Response to Comments on the Draft 1 Specification Revision

Version 7 ENERGY STAR® for Windows, Doors, and Skylights

2. Draft 2 Proposed Climate Zone Map – NEW

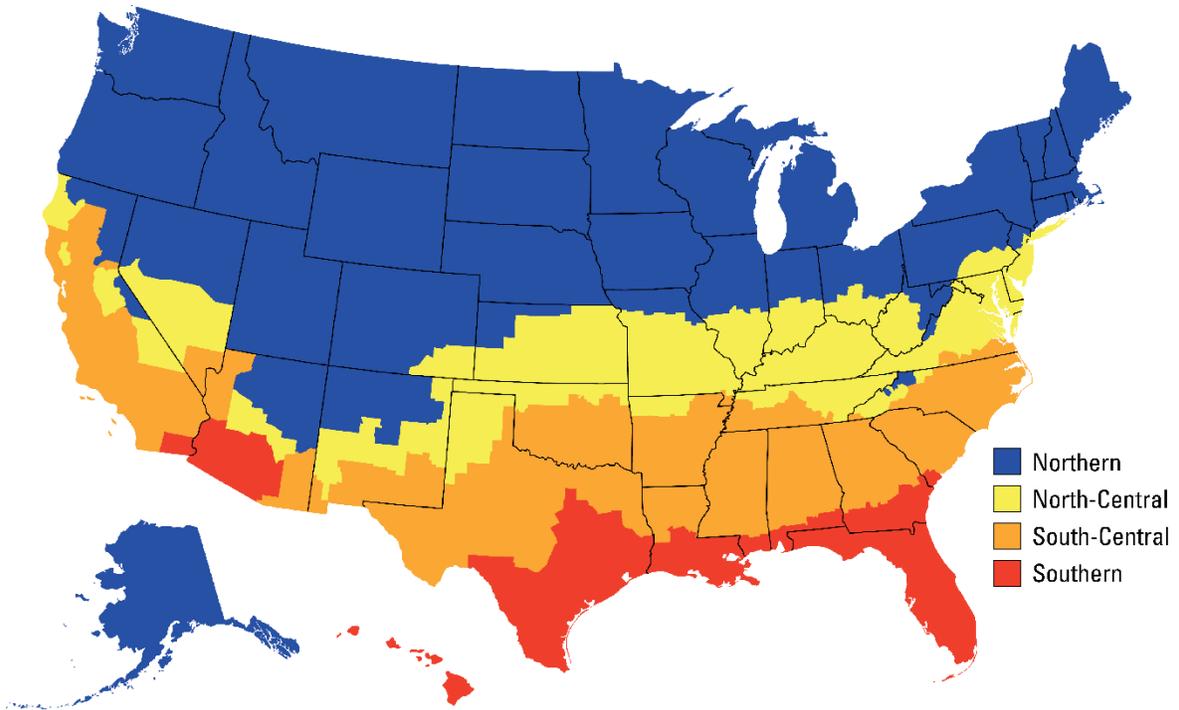
EPA updated the ENERGY STAR climate zone map to align with the IECC 2021 climate zone updates. In doing so, several high elevation areas were identified as Northern zone “islands” within the North-Central climate zone. EPA received comments to change the proposed map to include these areas in the North-Central climate zone. Specific comments included the following:

- Several commenters agreed with the approach of aligning the energy zones with IECC/ASHRAE but recommended removing the Northern zone “islands” in high elevation areas of CA and NC back into the North-Central Zone.
- Several commenters asserted that the islands would create product distribution challenges.

EPA appreciates the feedback regarding the Northern zone “islands” (isolated counties) in the Draft 1 version of the ENERGY STAR [climate zone map](#). EPA will change the proposed map to include these Northern zone high elevation islands back to the North-Central climate zone. In addition, EPA found a few islands between North-Central and South-Central locations and made those adjustments in the [Draft 2 climate zone map](#). EPA has provided a list of zone adjustments by county in [Appendix section X](#).
